Re: Northern Indiana Public Service Company  
Bailly Generating Station - Nuclear 1  
Docket No. 50-367

RESPONSE TO NRC REQUESTS FOR INFORMATION

OF JUNE 28, 1979

FIGURE 1-7

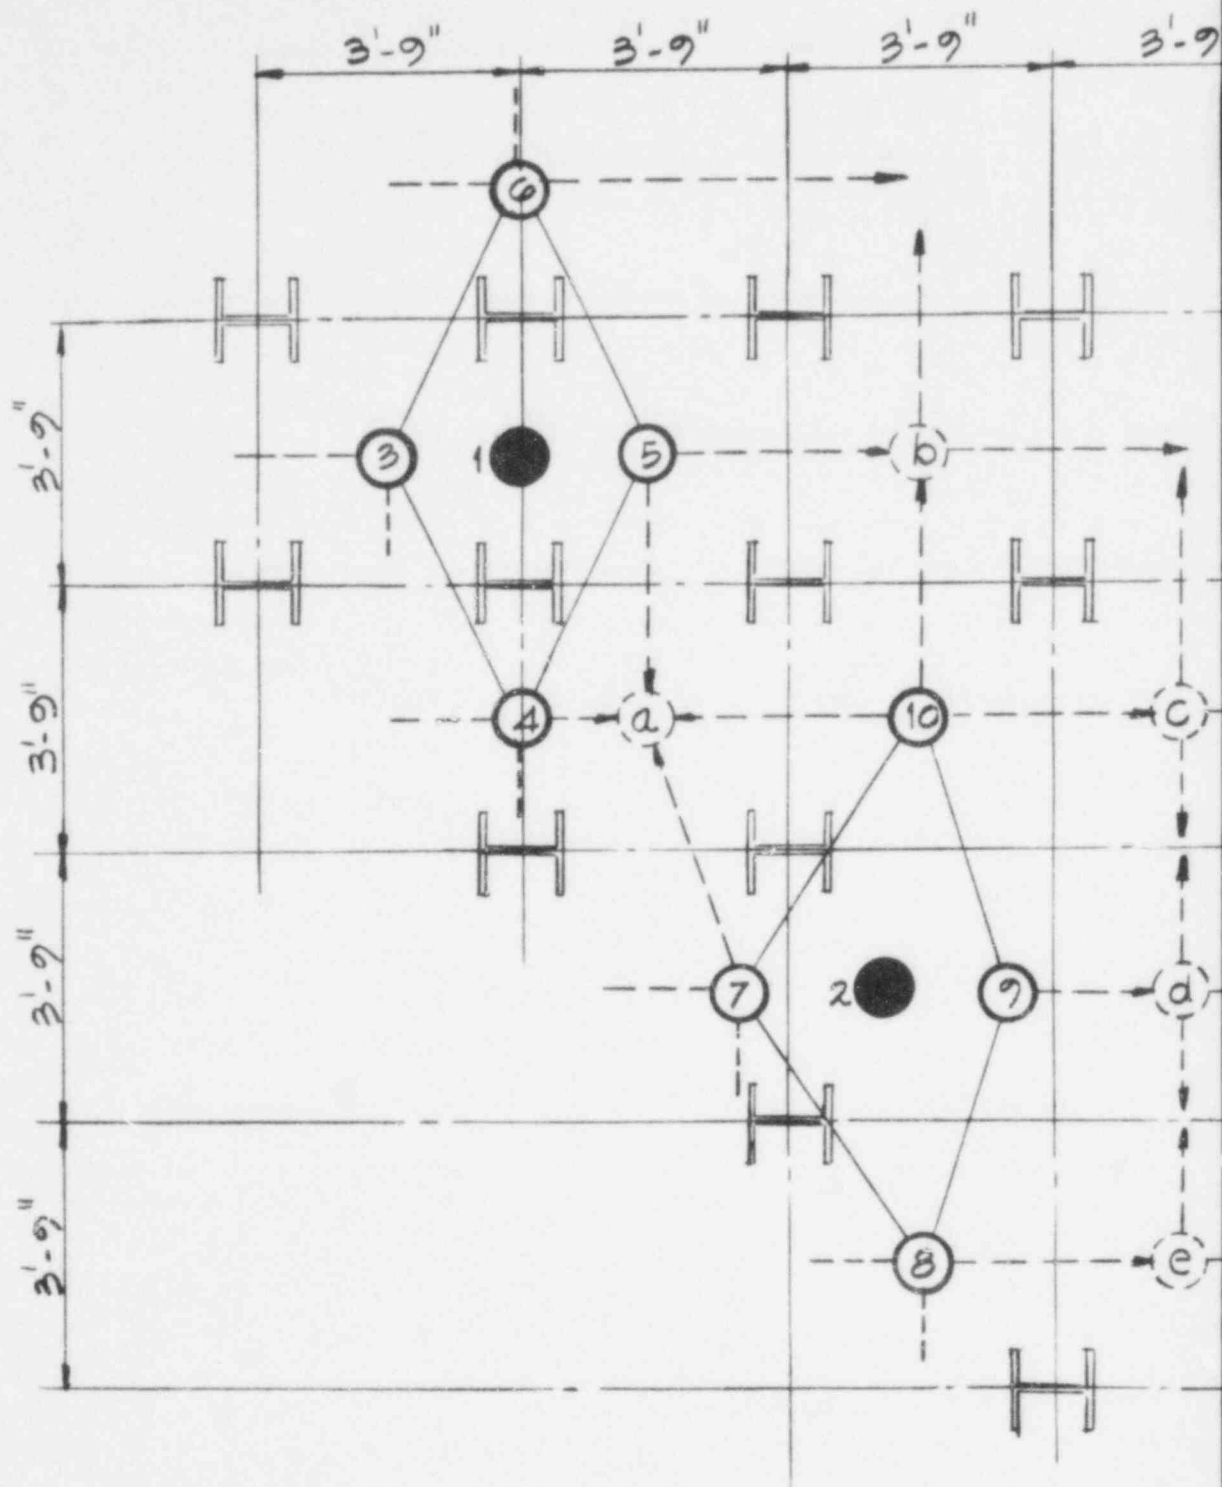
disturbance at that location, then additional densification piles will be driven around that particular pile in accordance with the example shown on Figure 1-7. These piles will be driven to penetrate the identified depth of disturbance or until they reach refusal, whichever occurs first. This procedure will be repeated until the driving records of densification piles indicate that densification has been achieved.

- III. EXAMINE THE NEED FOR ADDITIONAL DENSIFICATION PILES:
  - i. ALL POTENTIAL ADDITIONAL DENSIFICATION PILES ARE SHOWN BY THE OPEN DASHED CIRCLES.
  - ii. THE NEED TO DRIVE AN ADDITIONAL DENSIFICATION PILE AT THE LOCATION DESIGNATED "a" WILL BE DETERMINED BY EXAMINING THE DRIVING RECORDS OF PILES NO. 4, 5, 7 AND 10 AND COMPARING THE RECORDS WITH THE DRIVING RECORD FOR THE NEAREST CONTROL PILE. THE EVALUATION WEIGHS THE IMPORTANCE OF EACH OF THESE PILES TO TAKE INTO ACCOUNT THEIR LOCATION RELATIVE TO THE POTENTIAL PILE LOCATION.

- iii. ALL OTHER POTENTIAL LOCATIONS ARE EVALUATED BY EXAMINING THE PILE DRIVING RECORDS OF THE ADJACENT PILES, AS INDICATED BY THE ARROWS STARTING FROM THE ALREADY DRIVEN PILES. IN THIS MANNER, ANY OF THE PILES IDENTIFIED AS a to e MAY BE DRIVEN, DEPENDING ON THE RESULTS OF THE DRIVING RECORDS OF THE PILES IN THE VICINITY.

- iv. THE PROCESS IS REPEATED SEQUENTIALLY UNTIL THE LAST DRIVEN PILES SHOW NO SIGNS OF DISTURBANCE.

FIGURE 1-8

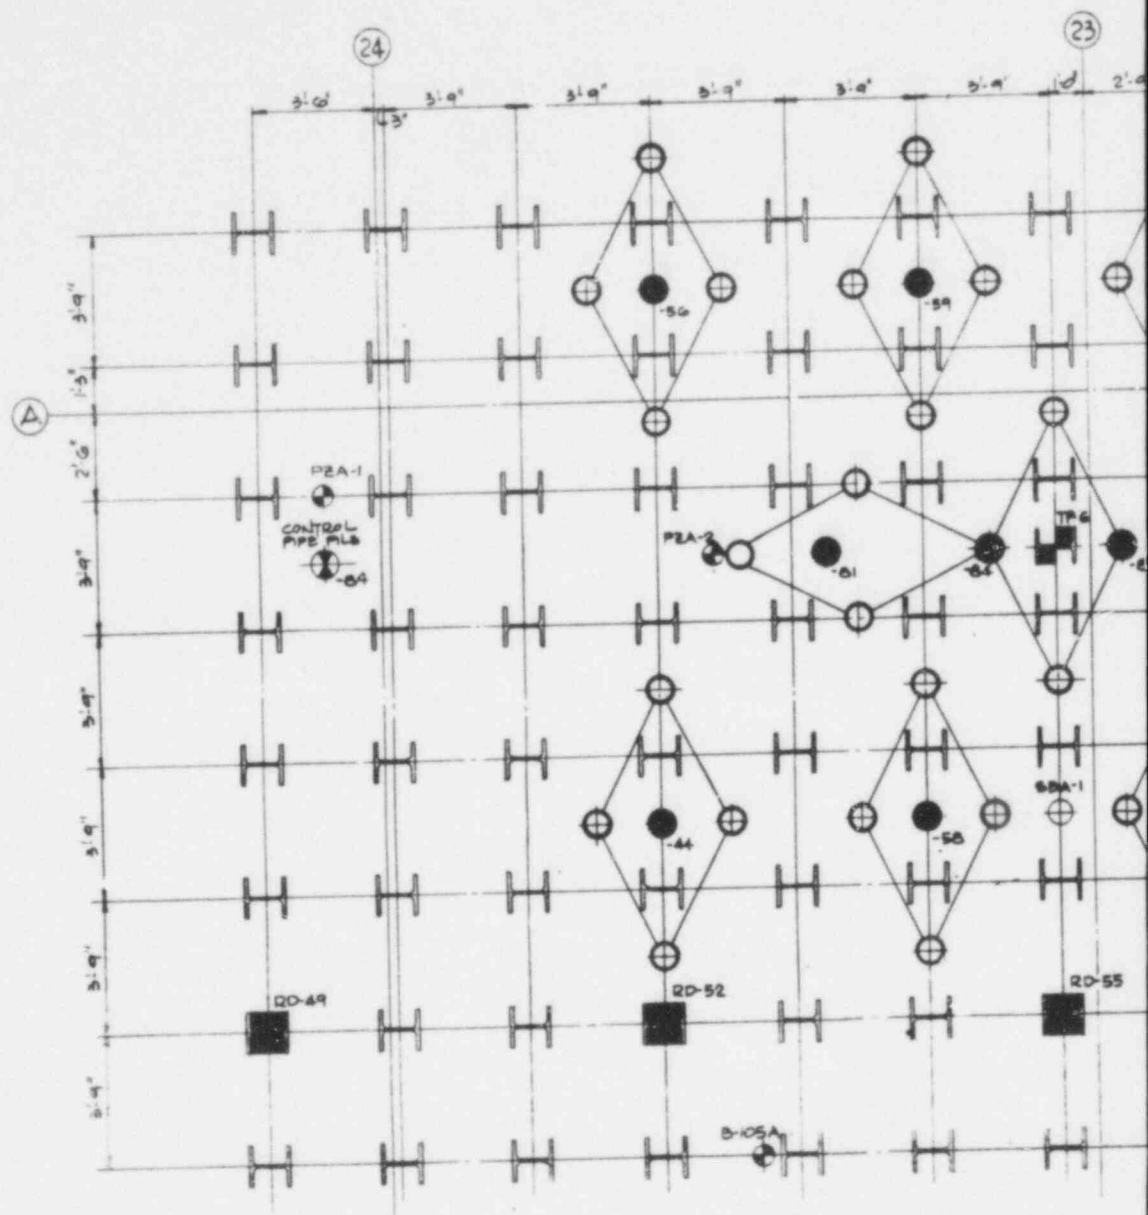
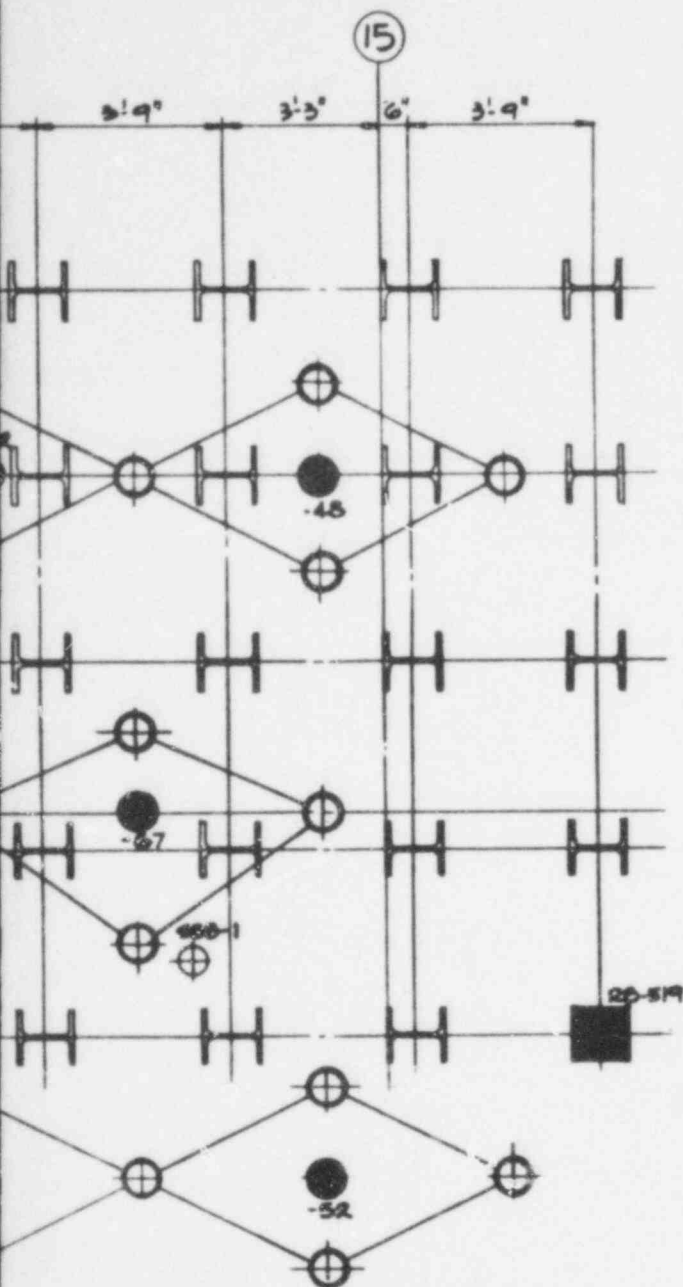
#### 1.3.1 Preconstruction Area A (Figure 1-8)

- a) One supplementary boring, SBA-1, will be drilled midway between the locations of two anchor piles (both of which were jetted to elevation -53).
- b) Two control pipe piles will be driven. One is located close to boring PZA-1, which showed no disturbance, and the other is next to indicator pile RD-64, which met the driving criteria.

- c) Two verification borings will be drilled close to borings PZA-2 and SBA-1 to evaluate the effectiveness of the densification program.

FIGURE 1-9

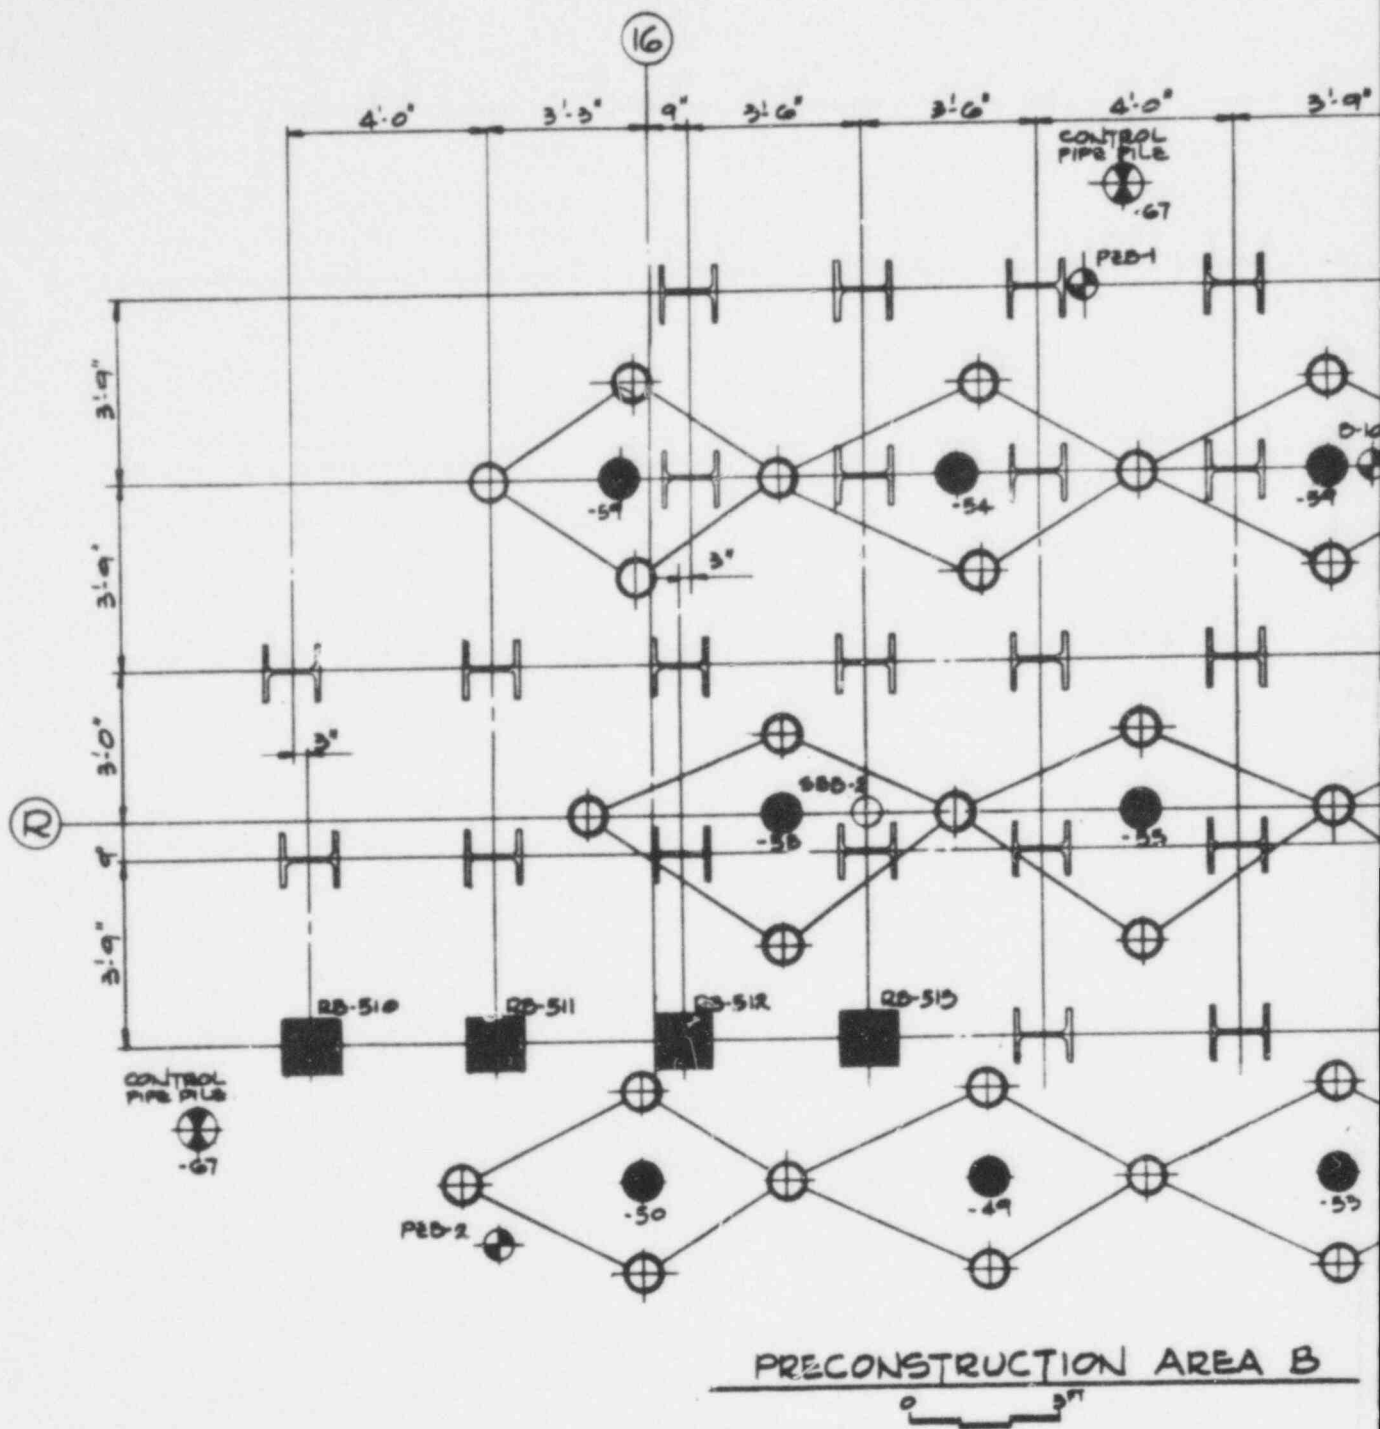
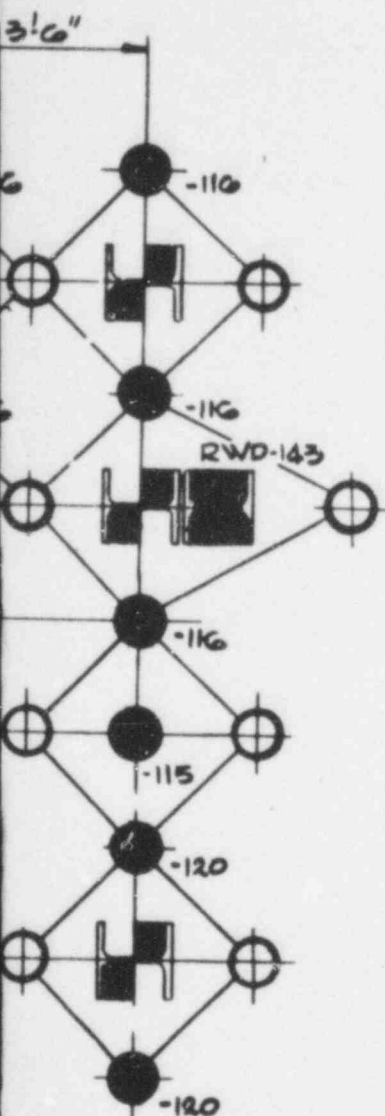
#### 1.3.2 Preconstruction Area B (Figure 1-9)

- a) Two supplementary borings will be drilled at the locations identified as SBB-1 and SBB-2. They are close to two piles which were installed with the assistance of jetting and, therefore, soil disturbance is expected.
- b) Two control pipe piles will be driven. One pile will be located close to boring PZB-1, which showed no disturbance. The other control pile will be located close to the indicator pile RB-510, which met the driving criteria.
- c) Two verification borings will be drilled close to borings SBB-1 and SBB-2 to verify the effectiveness of the densification program.

FIGURE 1-10

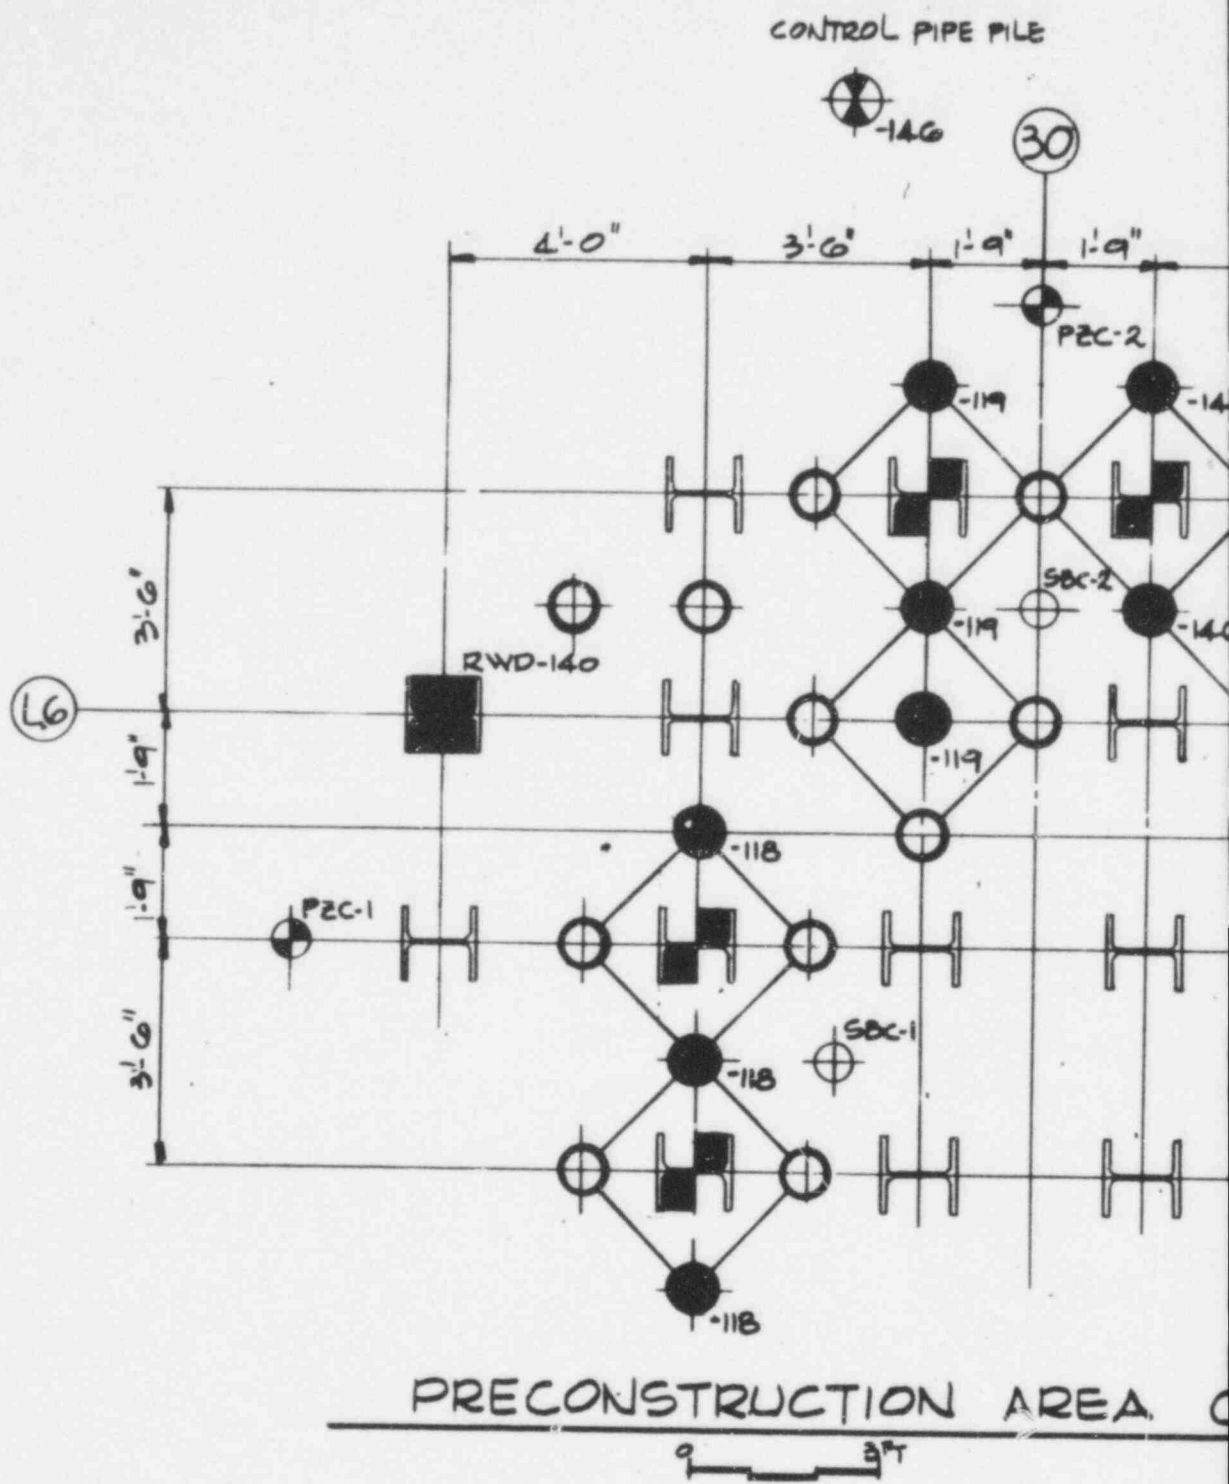
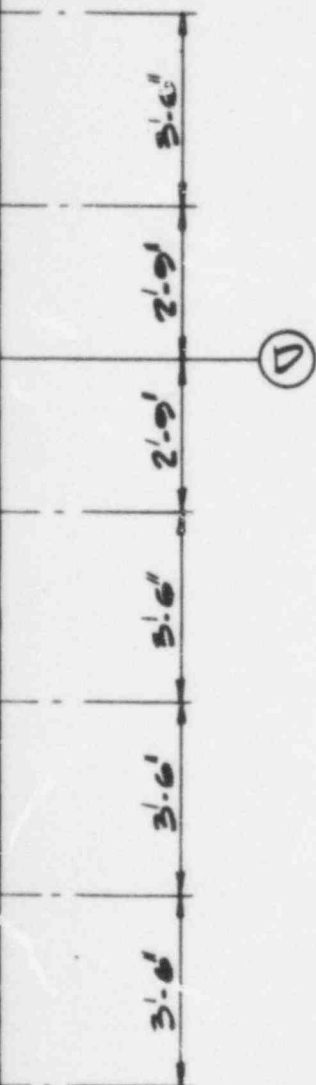
#### 1.3.3 Preconstruction Area C (Figure 1-10)

- a) Two supplementary borings will be drilled at the locations identified as SBC-1 and SBC-2. They are located close to piles where jetting was most extensive.

- b) One control pipe pile will be driven a few feet from boring PZC-2. This pile will be close enough to boring PZC-2 to develop a correlation with the undisturbed soils.
- c) Two verification borings will be drilled close to borings SBC-1 and SBC-2 to verify the effectiveness of the densification program.

FIGURE 1-11

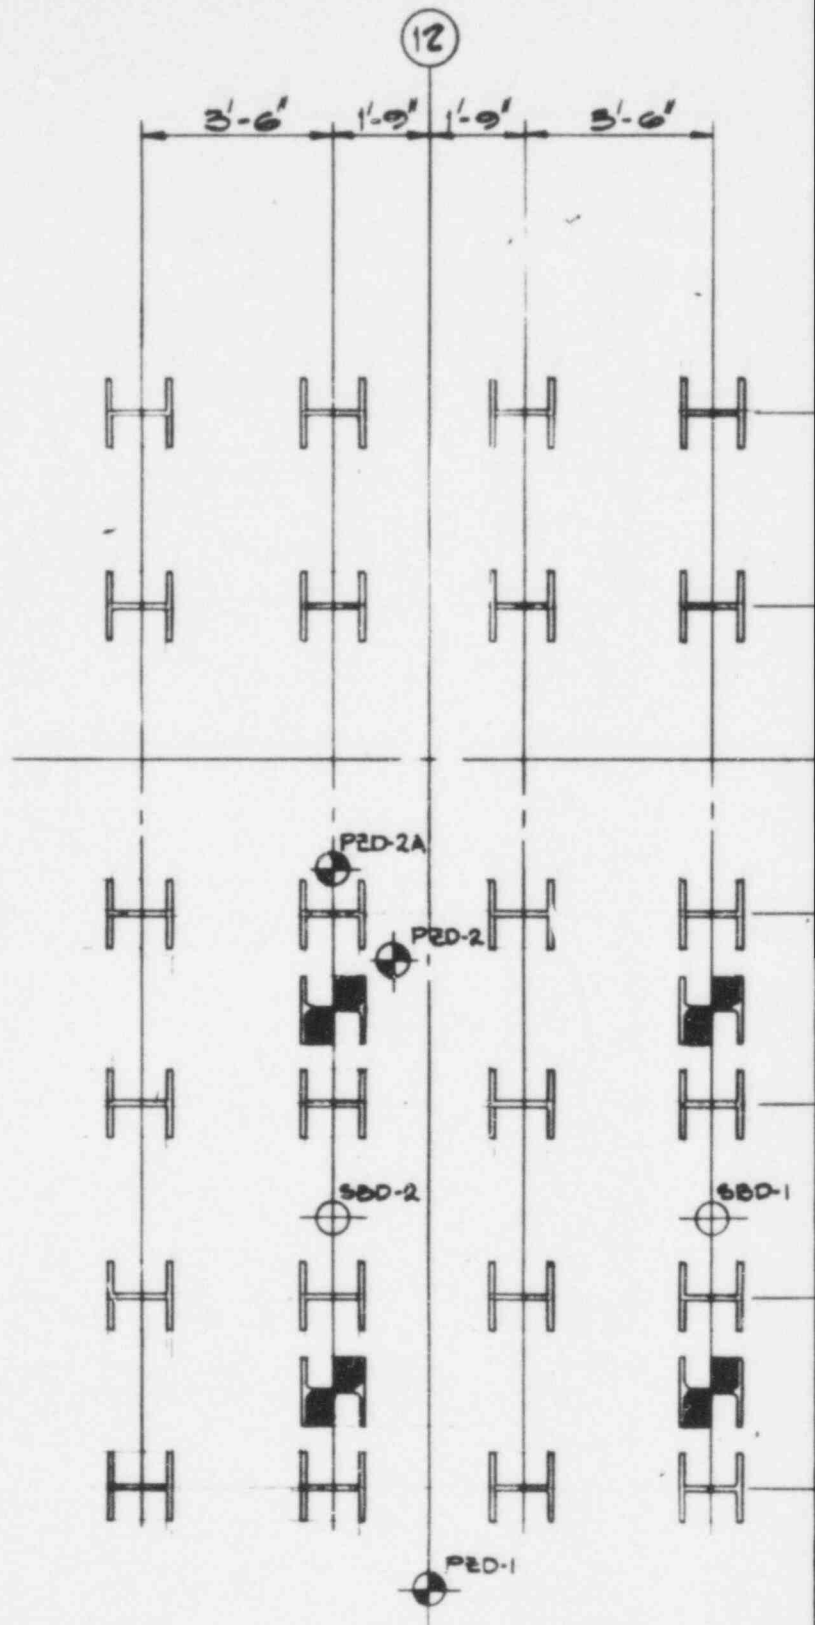
#### 1.3.4 Preconstruction Area D (Figure 1-11)

As explained in detail in Reference 1, it is believed that disturbance in this area is minor if indeed, it exists at all and, therefore, no densification piles are presently planned within this area.

Although four piles were installed by jetting or jetting and preaugering, the results of borings PZD-1 and PZD-2A, drilled within 2 to 3 feet from the jetted piles, showed no signs of disturbance. According to the records of the preconstruction activities, three of the four piles were driven to penetrate 40 to 80 feet below the depth to which jetting or augering took place. It is believed that the vibrations caused by the driving of these piles redensified the sands which might have been loosened by jetting and/or augering. Two supplementary borings SBD-1 and SBD-2 will be drilled at the approximate locations shown in Figure 1-11 to verify the conclusion that

the soils in this area are very dense and, therefore, do not require further densification. If these borings indicate that densification is necessary, a densification program following the guidelines detailed in paragraph 1.2 will be initiated.
